# ADDENDUM No. 1

ITB No. 4426

## SPRINGWATER SUBDIVISION IMPROVEMENTS PROJECT PHASE II

The following changes, additions, and/or deletions shall be made to the Invitation to Bid for **ITB No. 4426 Springwater Subdivision Improvements Project – Phase II**, on which proposals will be received on/or before Thursday, April 14, 2016, by 2:00P.M.

CURB OUTLET SAND FILTER INLET DETAIL

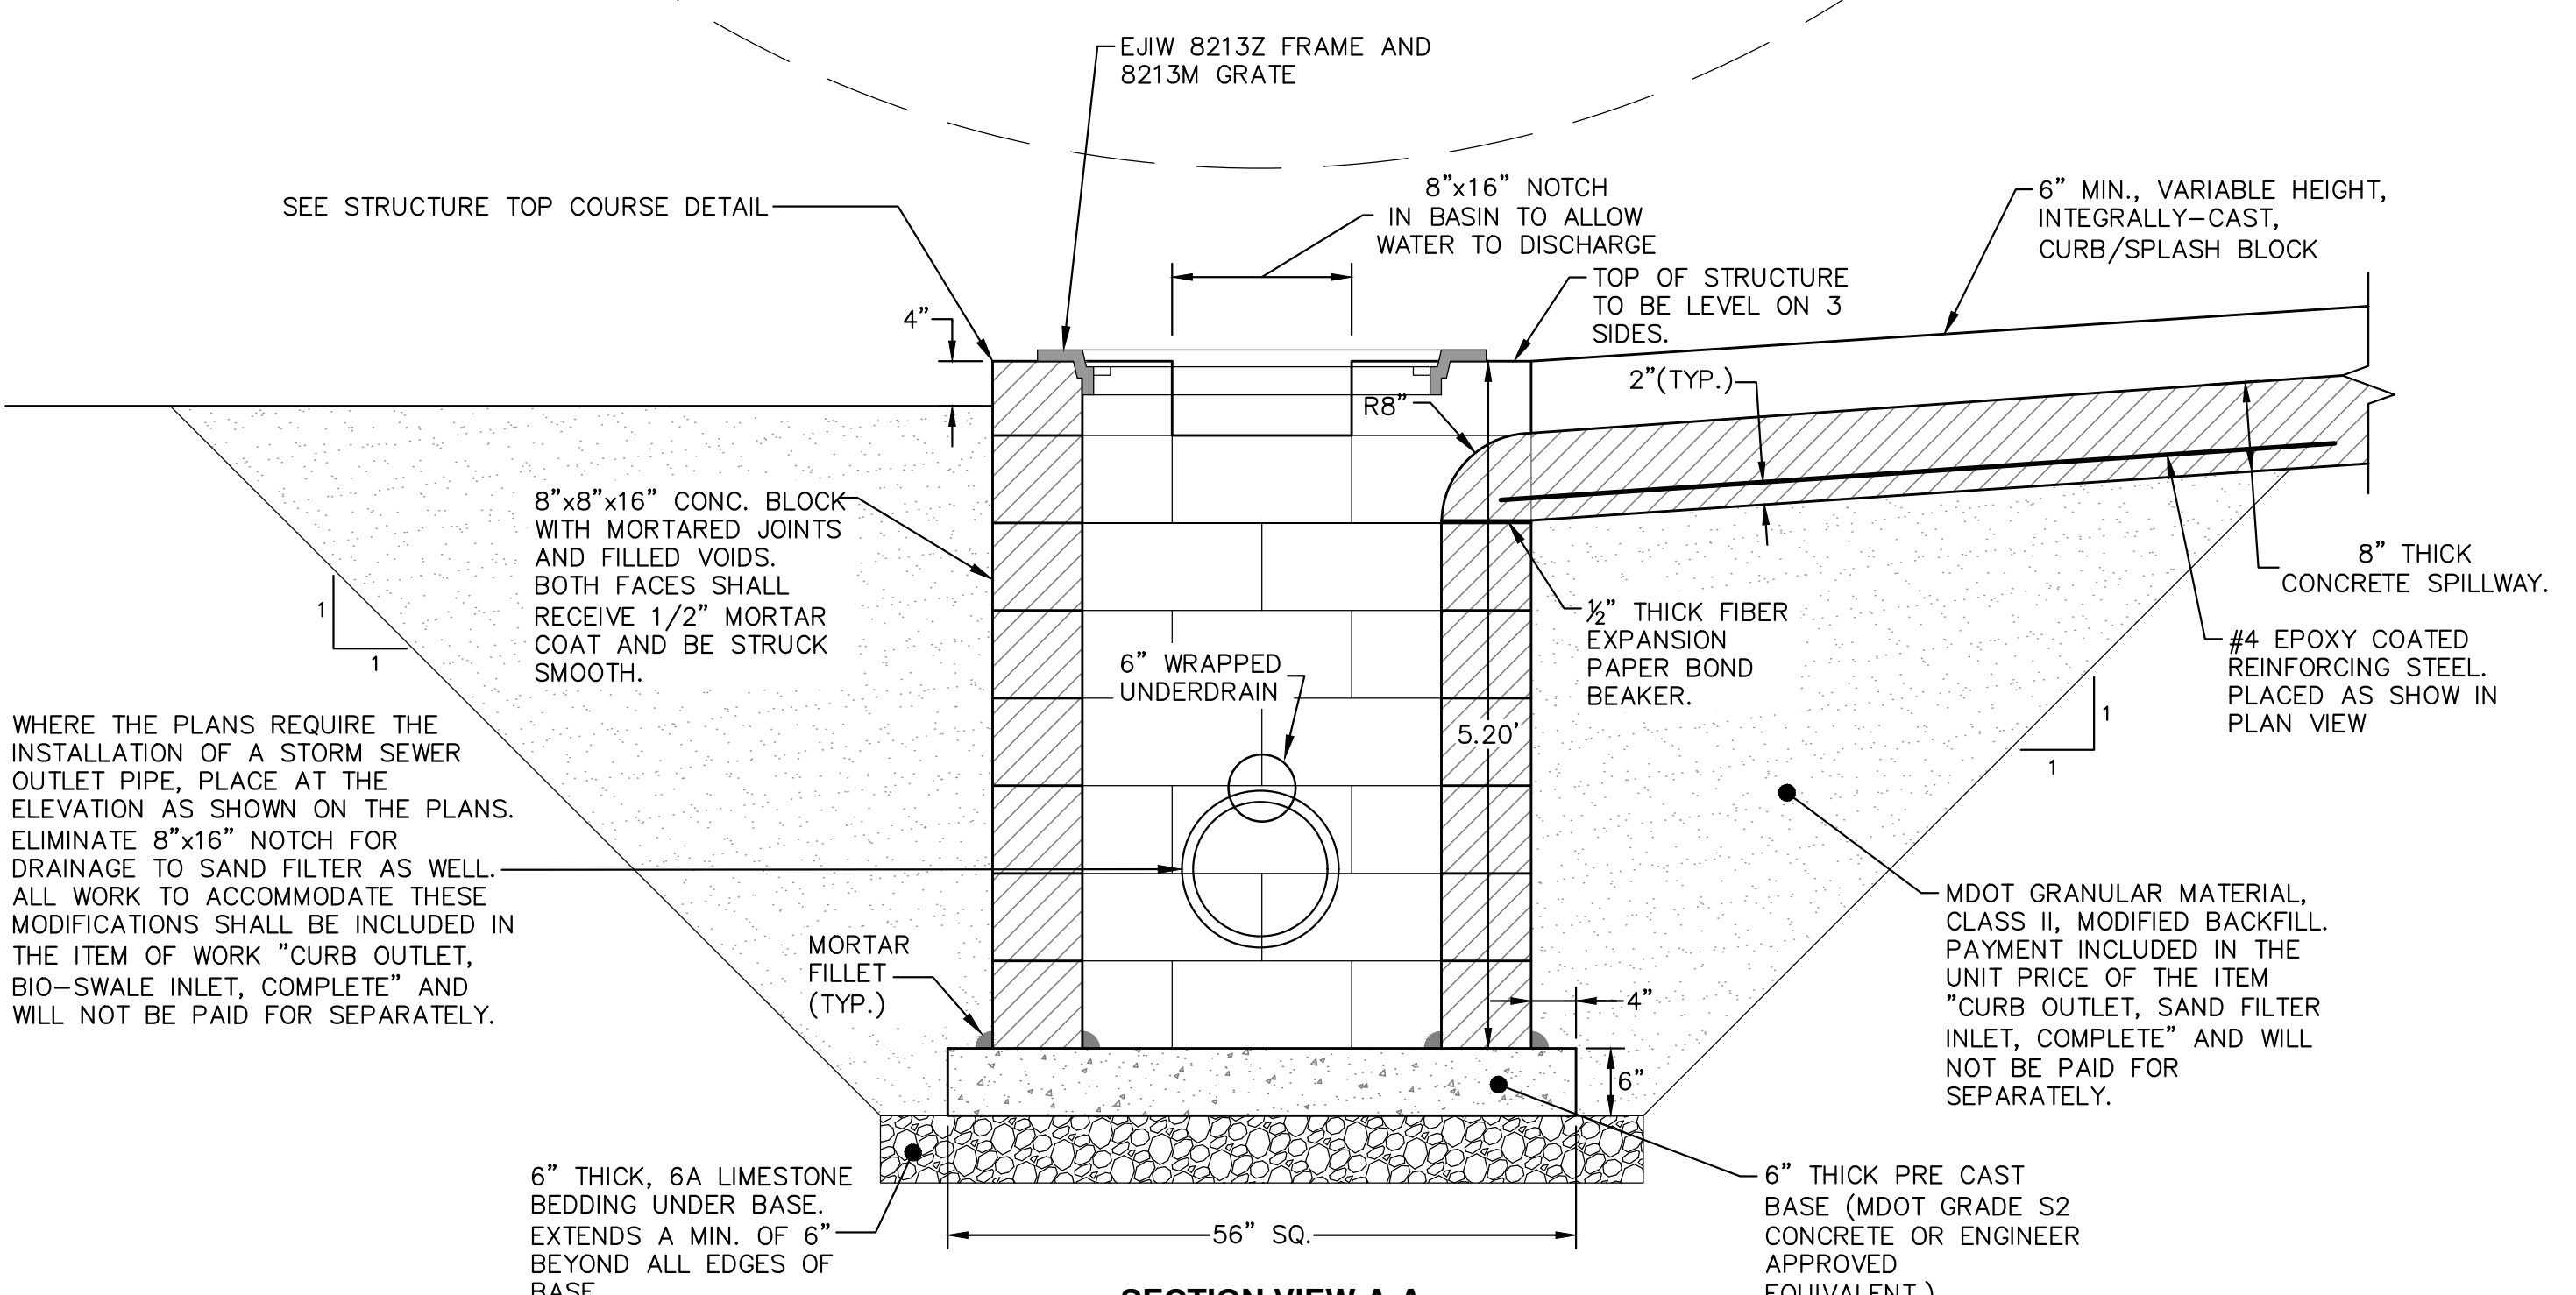
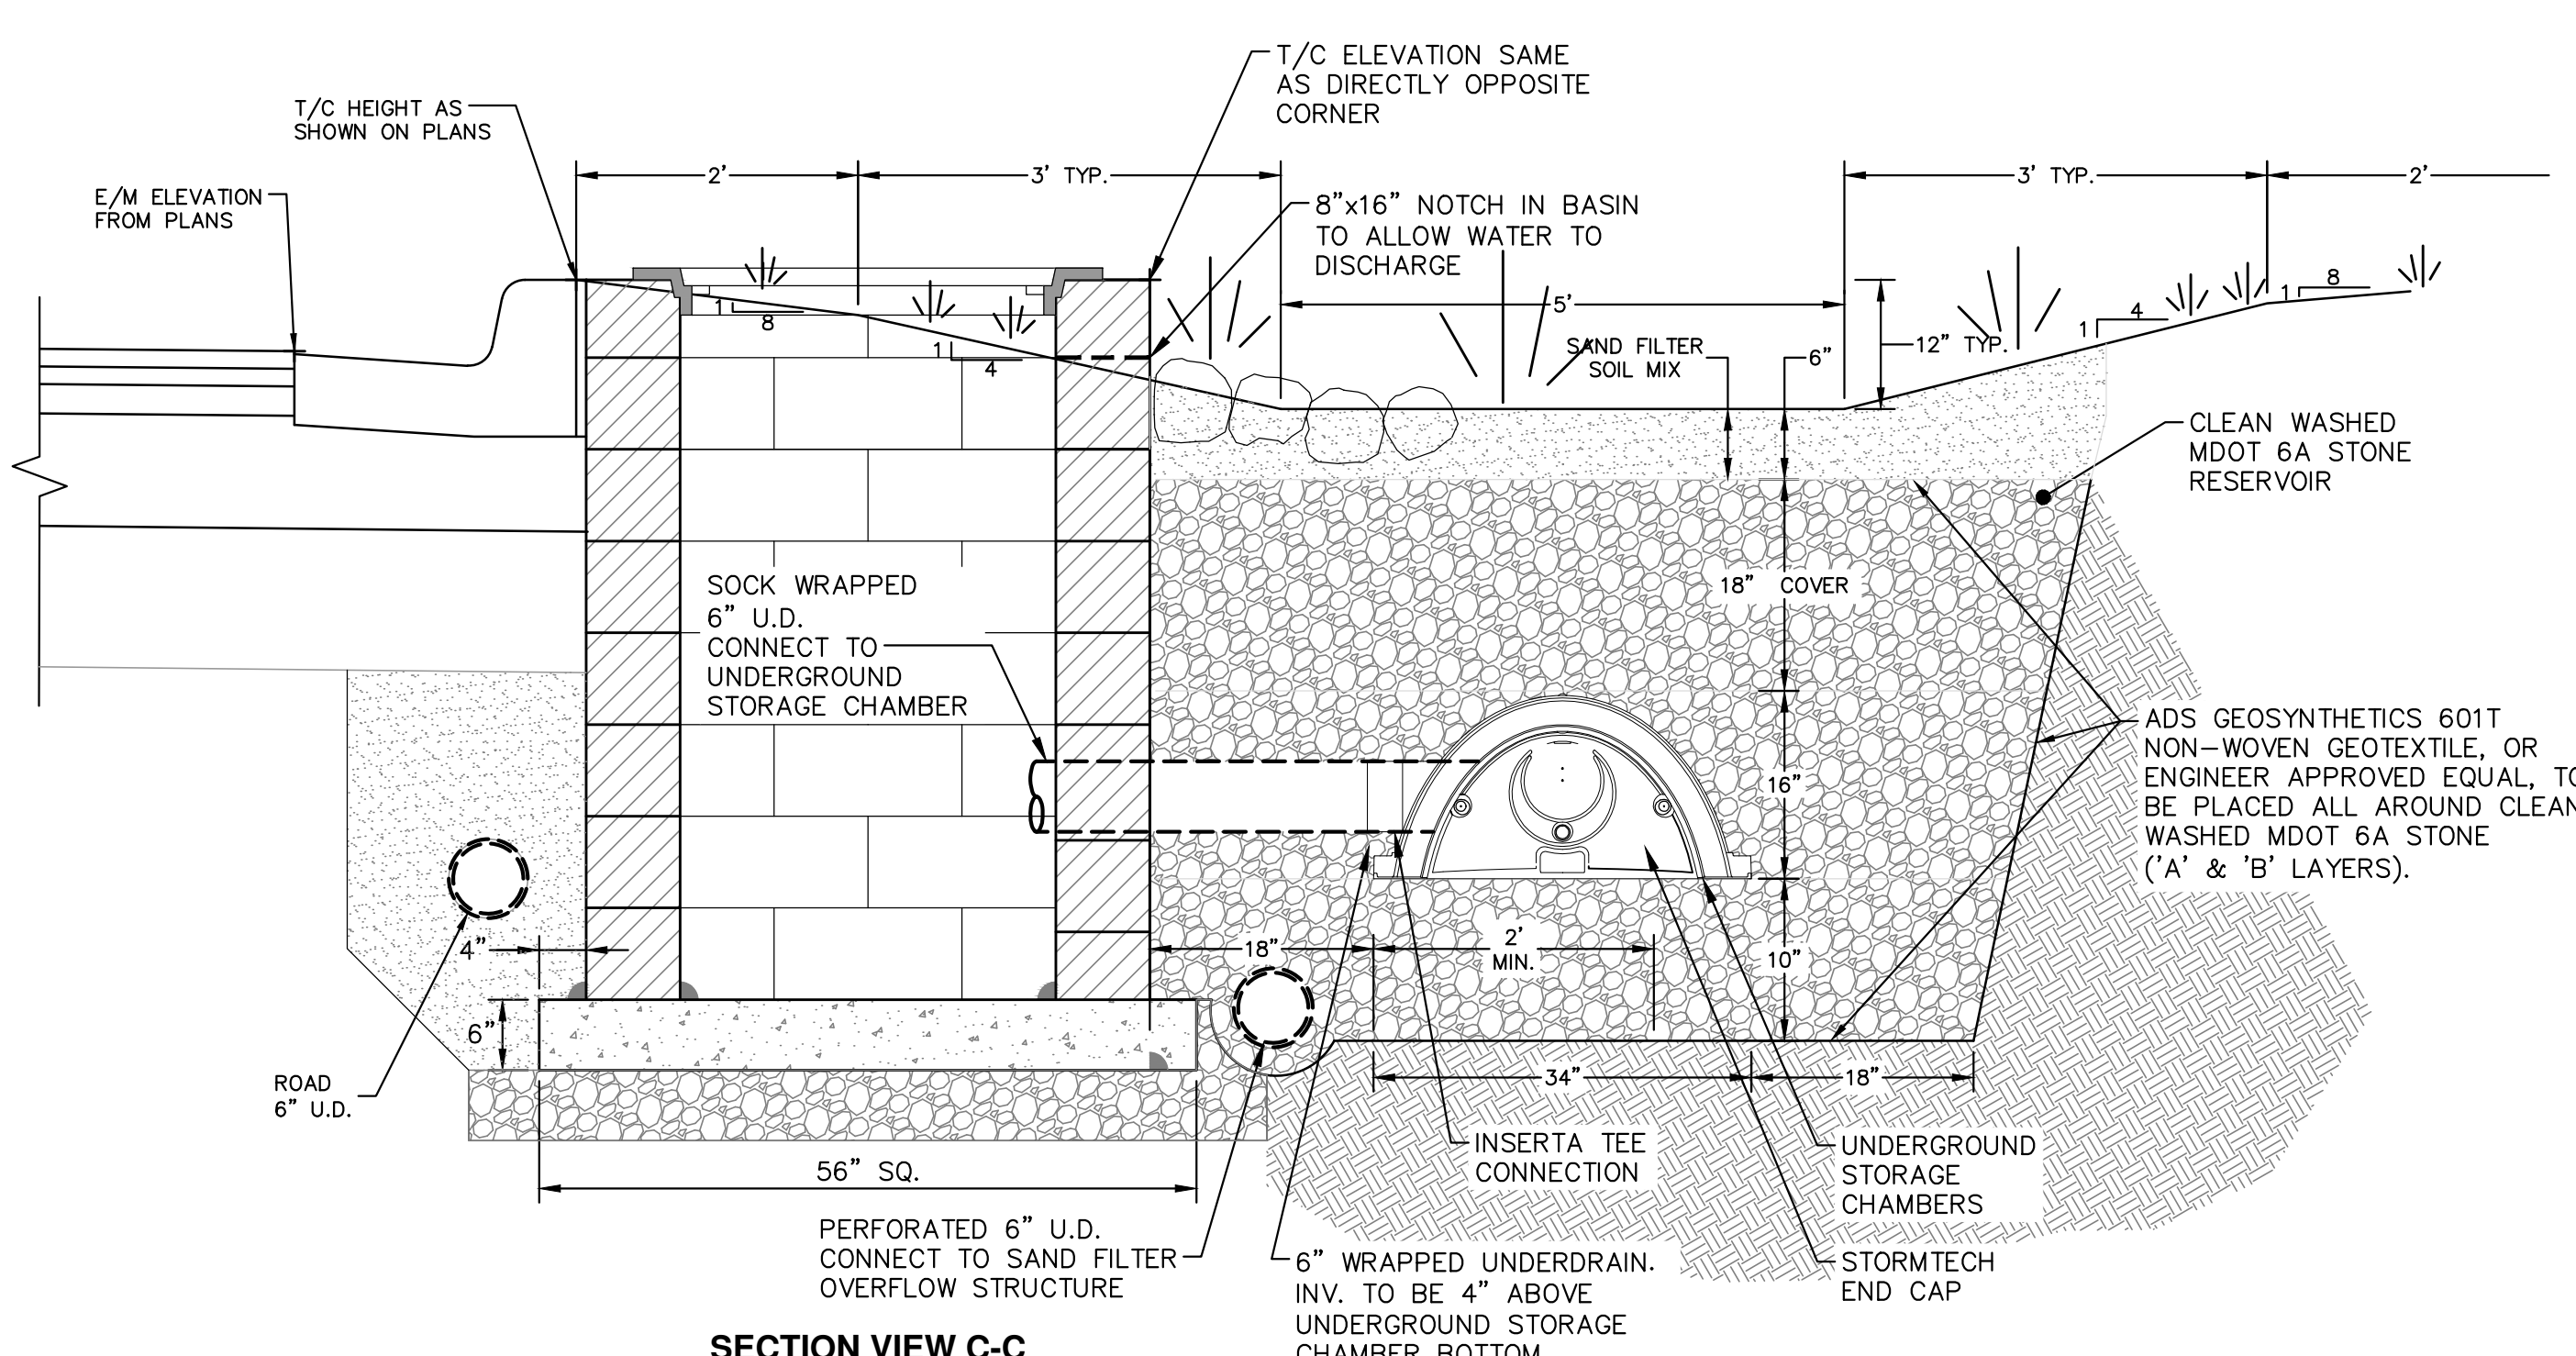
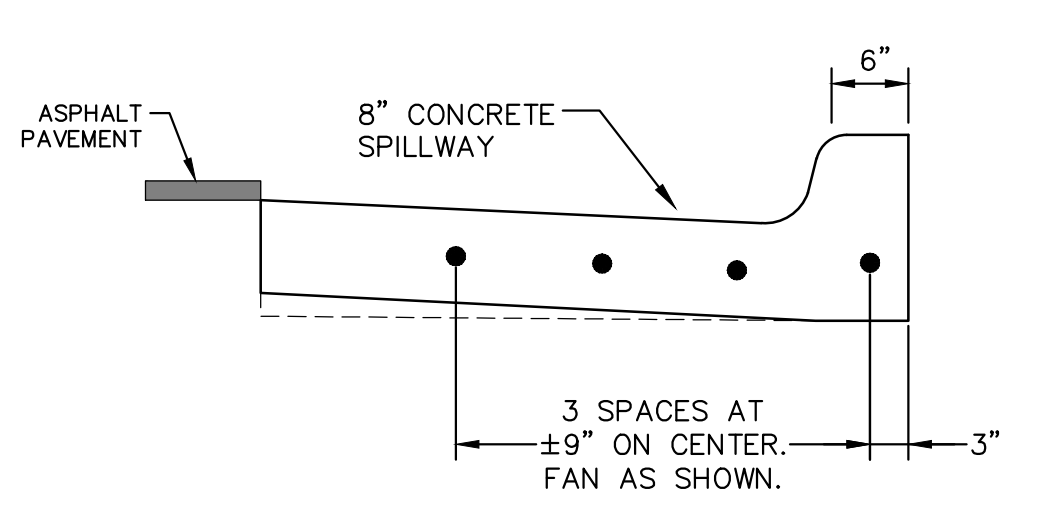
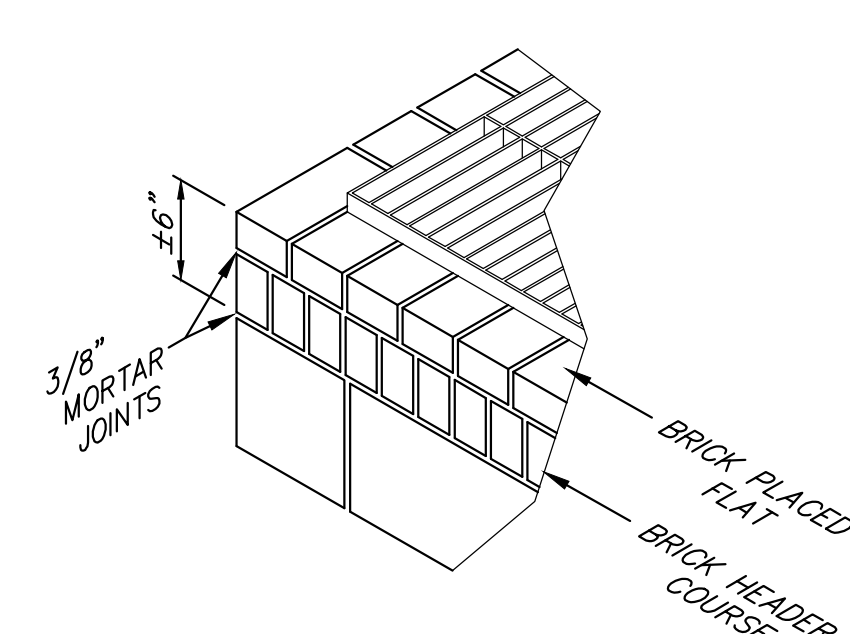
DS-36 – DS-42	The “Detailed Specification for Acceptance of HMA Mixtures” shall be deleted.
DS-79 – DS-85	These pages shall be removed and replaced by DS-79-R-1 through DS-85-R-1, which are attached below.
Plans Sheets 3, 6, 7 & 8	<p>These plan sheets shall be removed and replaced with the attached plans sheets #3, 6, 7 and 8. The significant changes to these plans sheets include the following:</p> <p>On plan sheet #3 the 12 inch sand subbase, CIP is shown to consist of MDOT Granular Material Class II, Modified.</p> <p>On plan sheet #6 the PVC membrane surrounding the sand filter was eliminated.</p> <p>On plan sheet #7 the aggregate stone barrier was eliminated at the top of the Sand Filter Overflow Structure detail.</p> <p>On plan sheets #4 &amp; #8 the aggregate backfill over the underground storage chambers is now identified as clean, washed MDOT 6A stone.</p>

- d. The PVC membrane surrounding the sand filter will be eliminated and will be reflected in Addendum #1.
- e. The aggregate stone backfill shall be eliminated at the top of the Sand Filter Overflow Structure detail and will be reflected in Addendum #1.
